STAFF RECOMMENDATION
2121 Westwood Avenue
September 18, 2019

Application: New Construction—Infill
District: Hillsboro-West End Neighborhood Conservation Zoning Overlay
Council District: 18
Base Zoning: RS7.5
Map and Parcel Number: 10415039900
Applicant: Blaine Bonadies
Project Lead: Melissa Baldock, melissa.baldock@nashville.gov

Description of Project: Application is to construct an infill house in front of the contributing house located at the back of the lot. **Recommendation Summary:** Staff recommends disapproval of the new construction, finding that its location, setbacks, and orientation do not meet Sections II. and III. of the design guidelines for the Hillsboro-West End Neighborhood Conservation Zoning Overlay.	**Attachments** **A:** Photographs **B:** Public Comment received as of 9/11/19 **C:** Site Plan **D:** Elevations

site plan

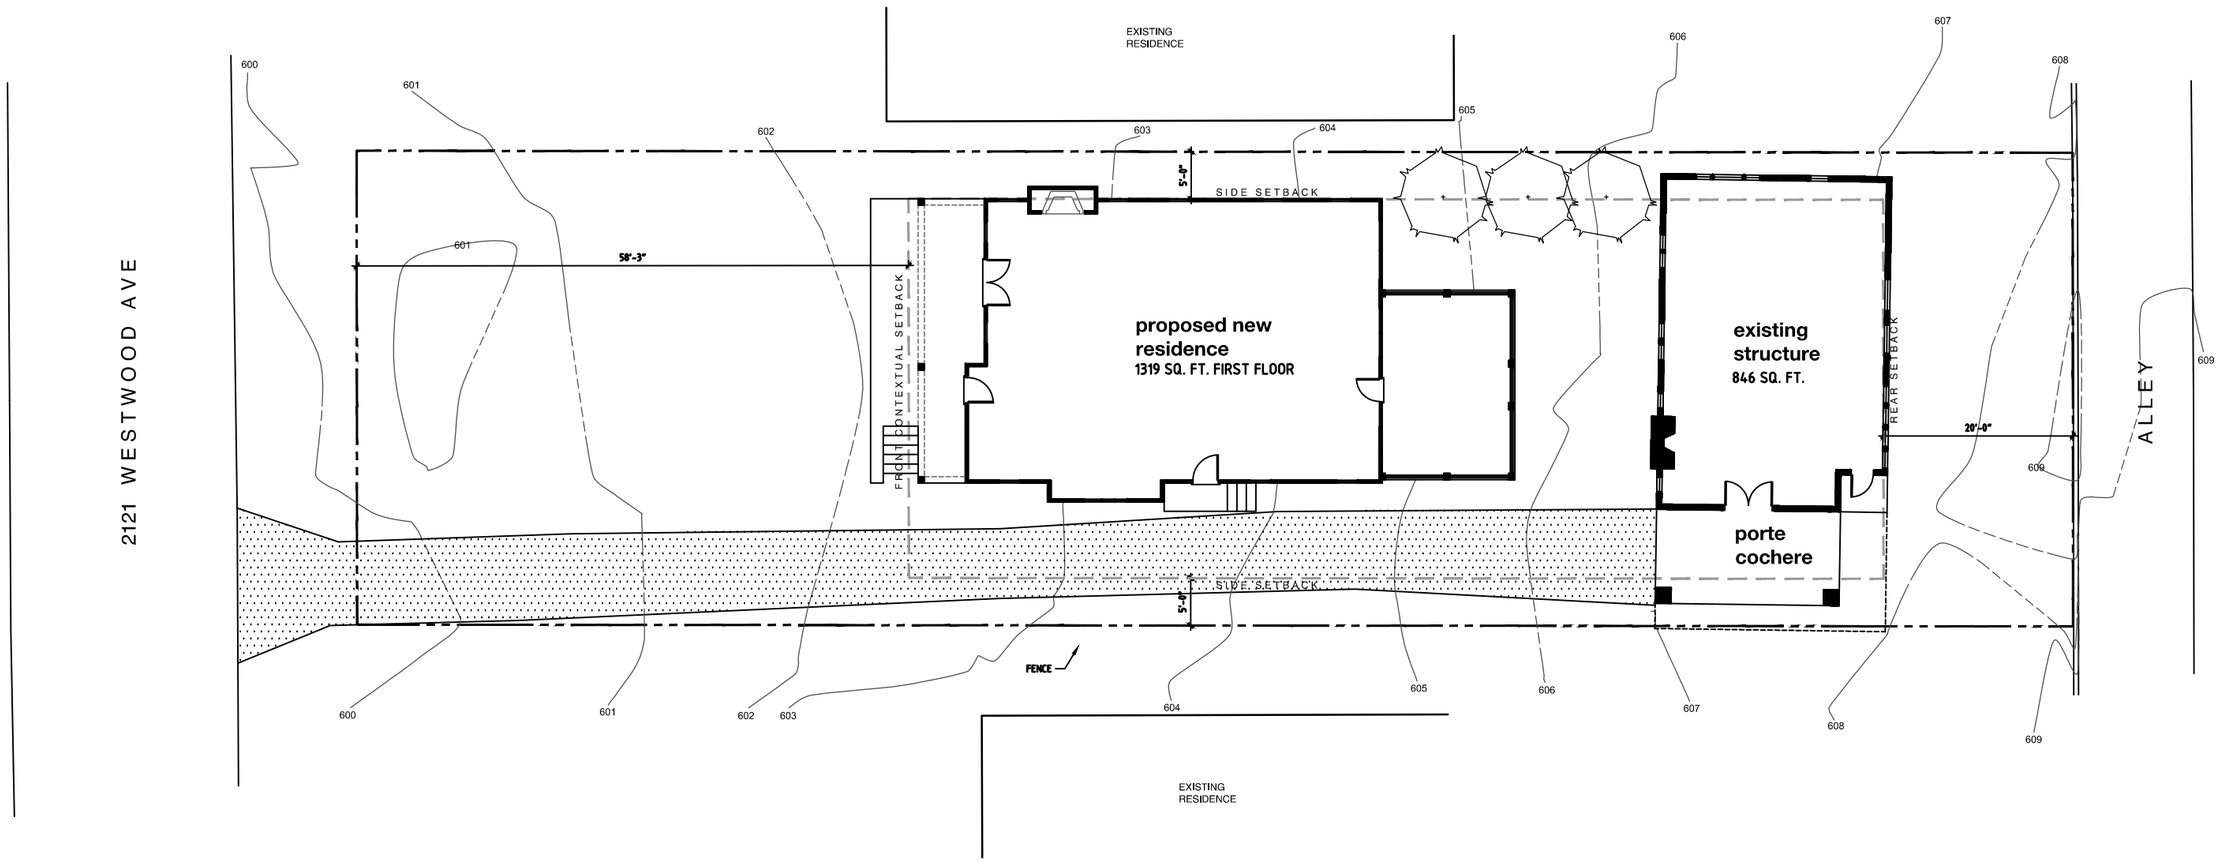
Setbacks: The design guidelines state that setbacks for new construction should be similar to adjacent buildings because the document assumes that the lot is vacant. This assumption can be made because the guidelines are based on the Secretary of Interior Standards, which states "the historic character of a property shall be retained and preserved. The removal of historic materials or alteration of features and spaces that characterize a property shall be avoided" (emphasis added). The deep front setback of this property is part of its historic character. Placing a building in front of the primary historic building irreparably changes its historic setbacks and forever removes a character defining historic space.

The design guidelines state that the dominant rhythm of the street should be maintained. Placing a building in front of the historic building greatly alters the historic rhythm of the street.

It is not known exactly why the builder of 2121 Westwood chose to build the house at the back of the lot; nonetheless, the history and character of this particular house and lot is that it has a deep front setback with a large front yard. The proposed infill would destroy the historic context of the existing, contributing structure, relegating it to the role of an outbuilding rather than a primary structure as it was originally intended. The proposal does not meet section II.B.c. for setback and rhythm of spacing.

Orientation: The design guidelines state that the orientation for new construction should be visually consistent with surrounding historic buildings, because the document assumes the lot is vacant. This assumption can be made because the guidelines are based on the Secretary of Interior Standards, which states "the historic character of a property shall be retained and preserved. The removal of historic materials or alteration of features and

spaces that characterize a property shall be avoided" (emphasis added). Placing a building in front of the primary historic building irreparably changes the historic building's orientation to the street.

The project does not meet section II.B.f for orientation.

Recommendation Summary: Staff recommends disapproval of the new construction, finding that its location, setbacks, and orientation do not meet Sections II. and III. of the design guidelines for the Hillsboro-West End Neighborhood Conservation Zoning Overlay.
